**Publication Date:** July 2023

**Affected Publication:** API Specification 16D, *Control Systems for Drilling Well Control Equipment and Control Systems for Diverter Equipment*, Third Edition, November 2018

## **Addendum 1**

Figure D.2: The content shall be replaced with the following:

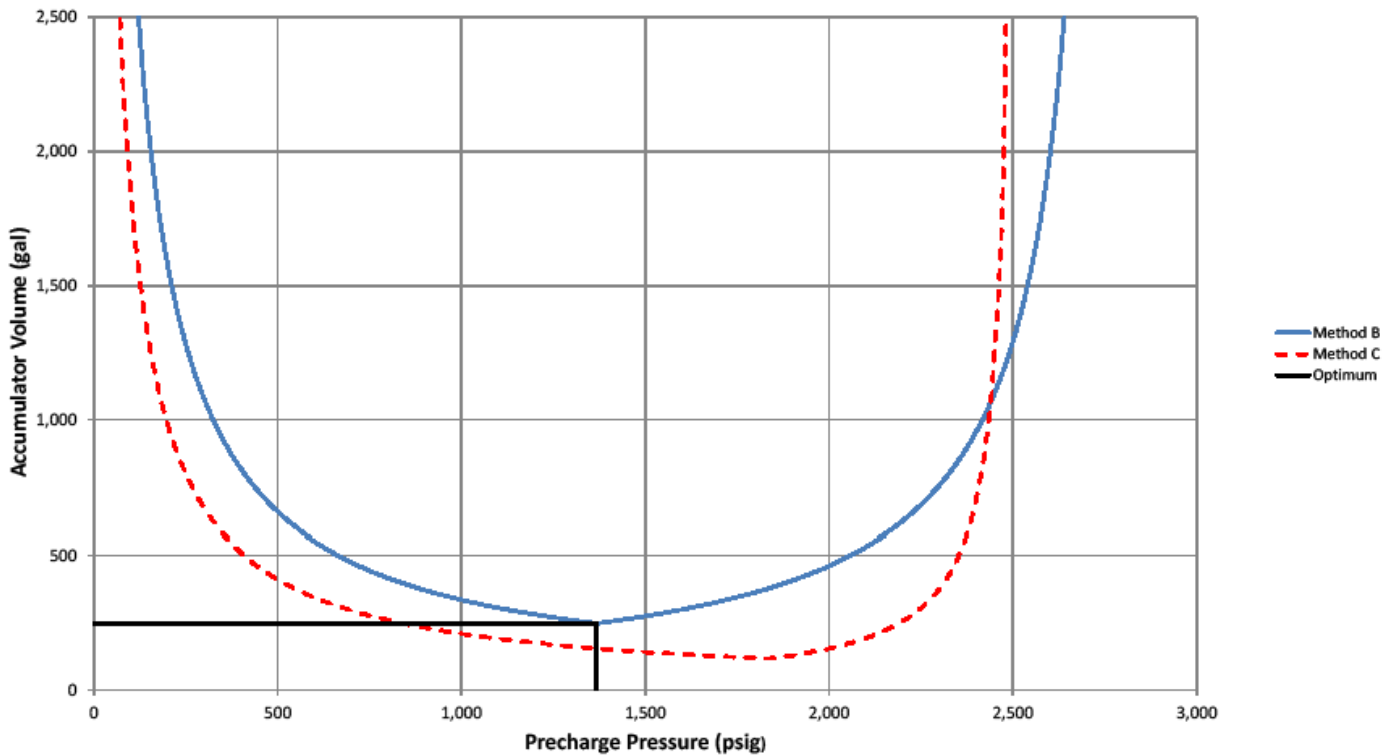
**Table D.5:** The content has been updated to remove the pipe ram from the well control sequence, and shall be replaced with the following:

Figure D.3: The content shall be replaced with the following:

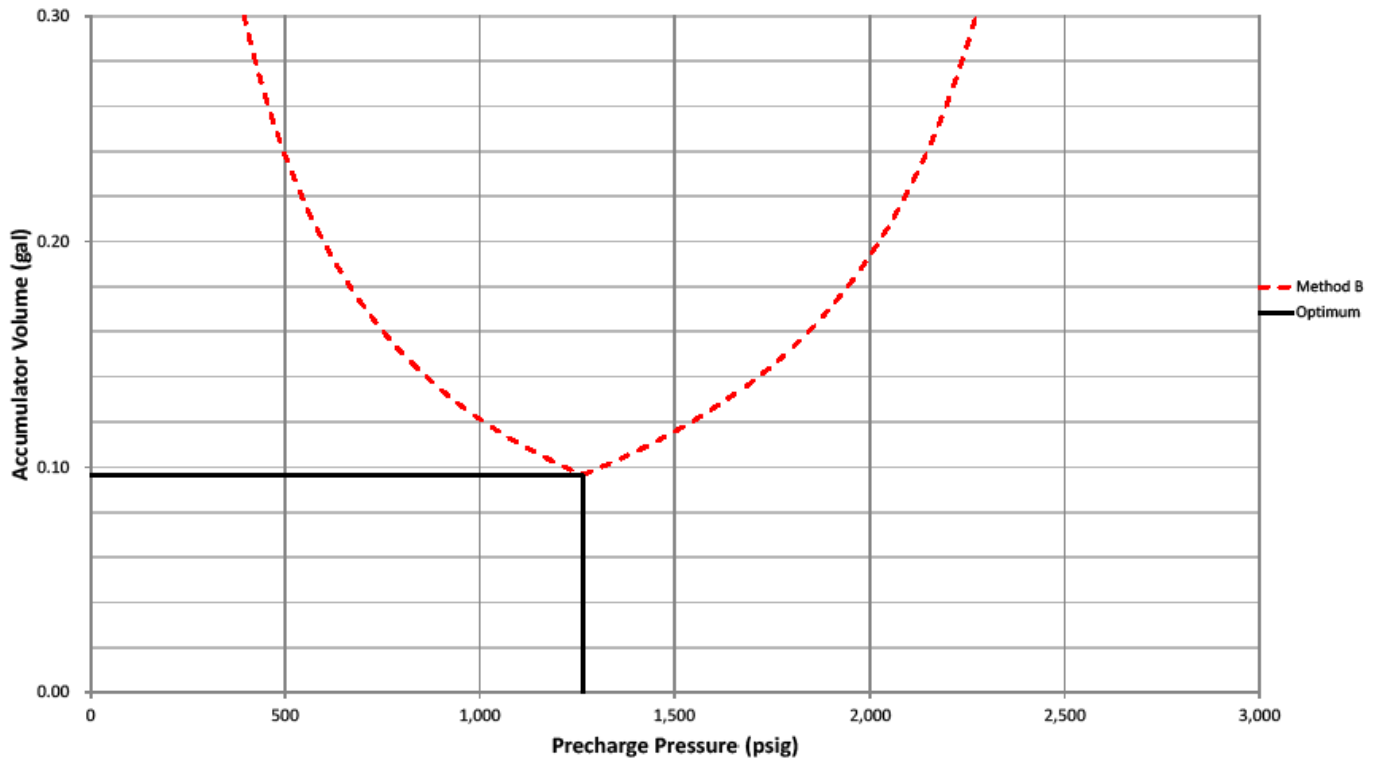
**Table D.6:** The content has been updated to change text from “200 % of volume to open and close all BOPs (FVR)” to “200 % of volume to close all BOPs (FVR)”, and shall be replaced with the following:

Figure D.5: The content shall be replaced with the following:

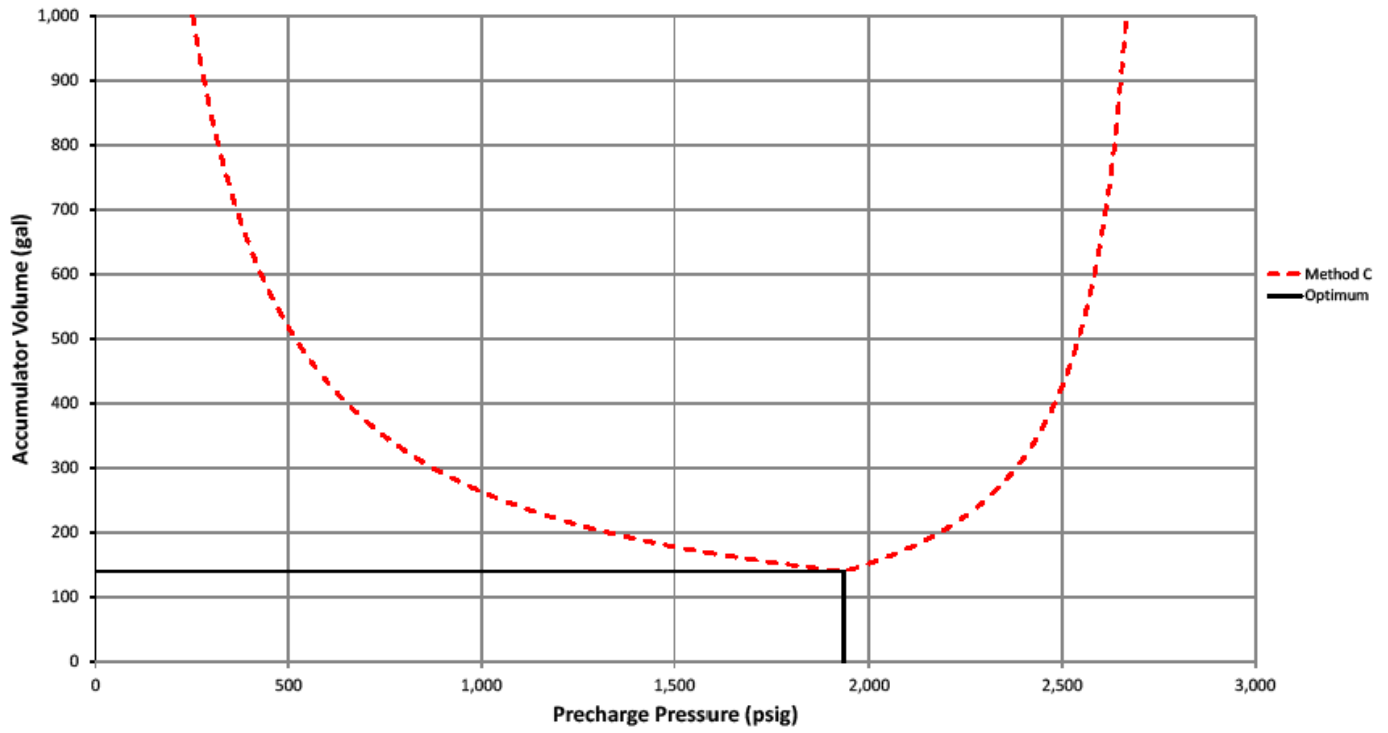
**Table D.8:** The content has been updated to correct over-writing text, and shall be replaced with the following:

Figure D.6: The content shall be replaced with the following:

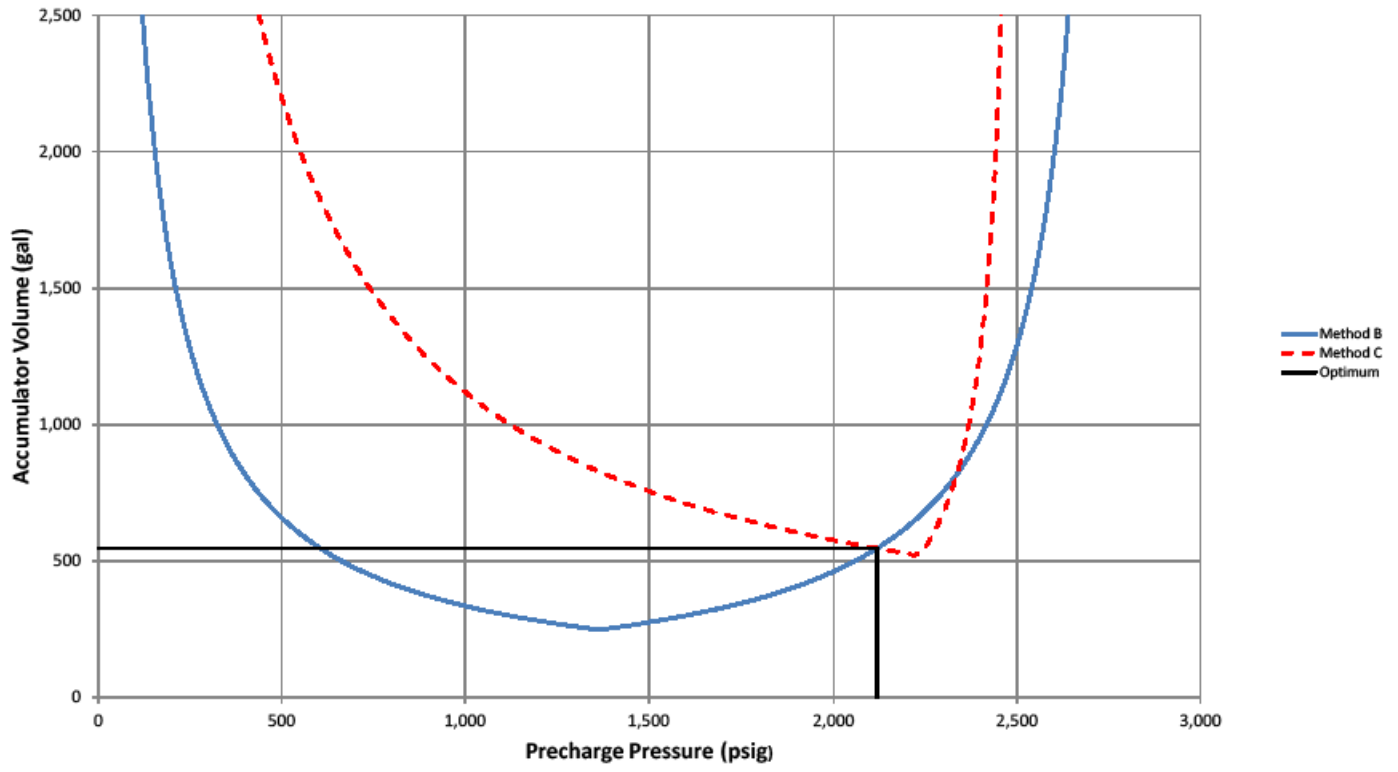
**Table D.9:** The content has been updated to remove the pipe ram from the well control sequence, and shall be replaced with the following:

Figure D.7: The content shall be replaced with the following:

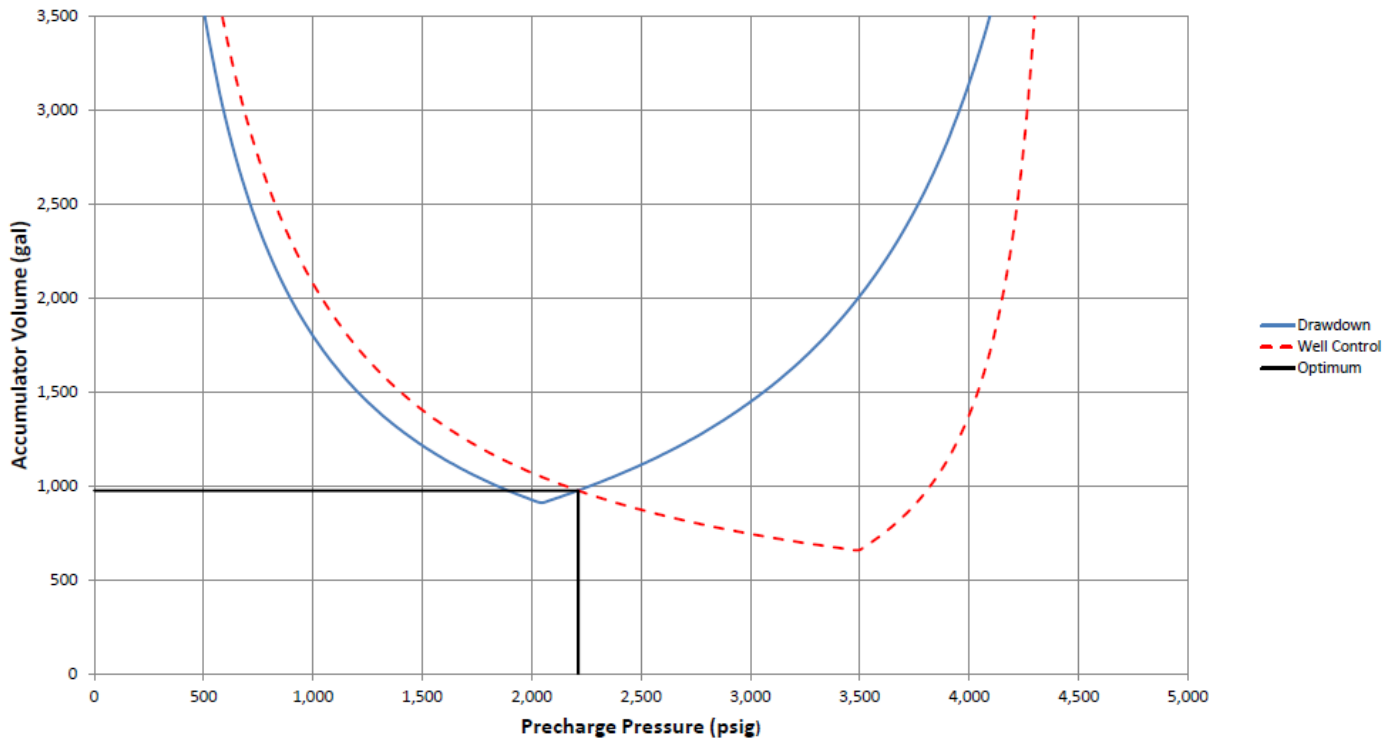
**Table D.10:** The content shall be replaced with the following:

Figure D.8: The content shall be replaced with the following:

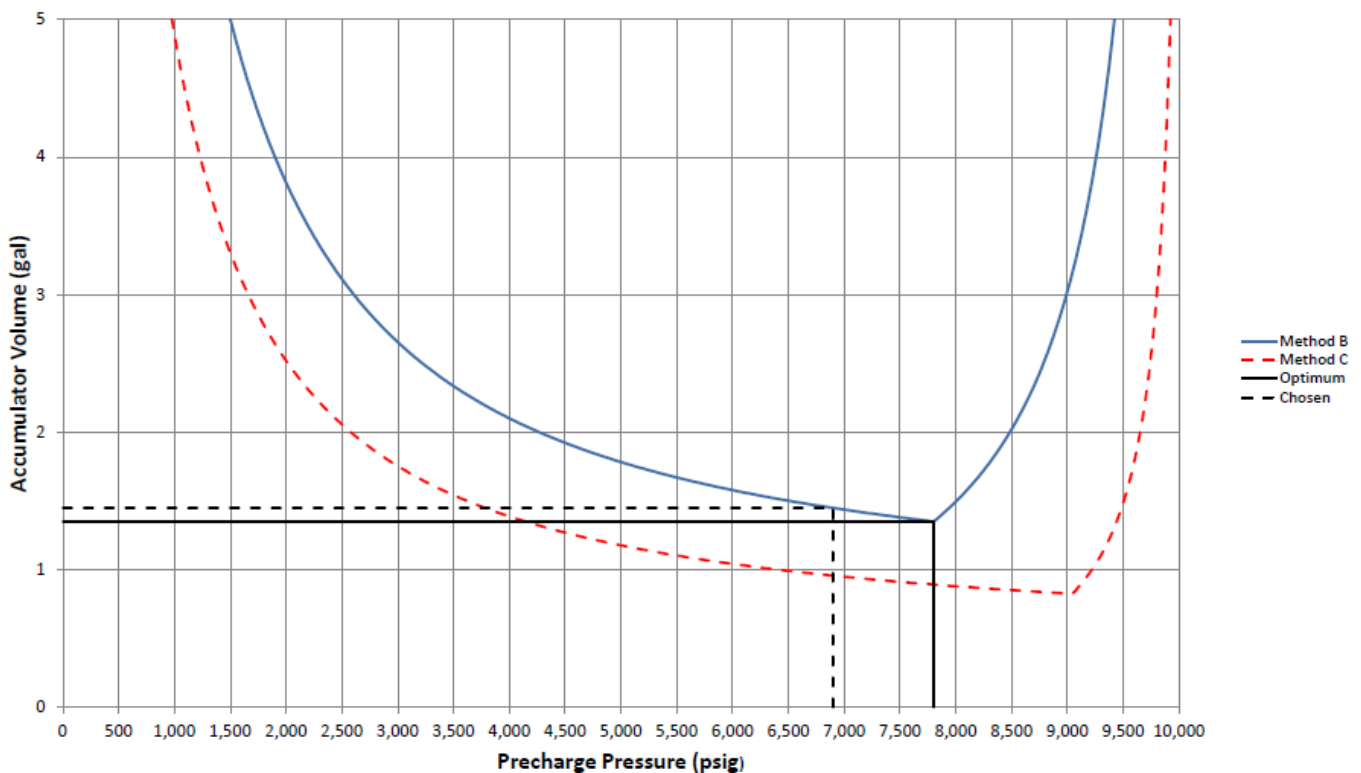
**Table D.12:** The content has been updated to incorporate regulator setting for MOPFLPS at RWP and shall be replaced with the following:
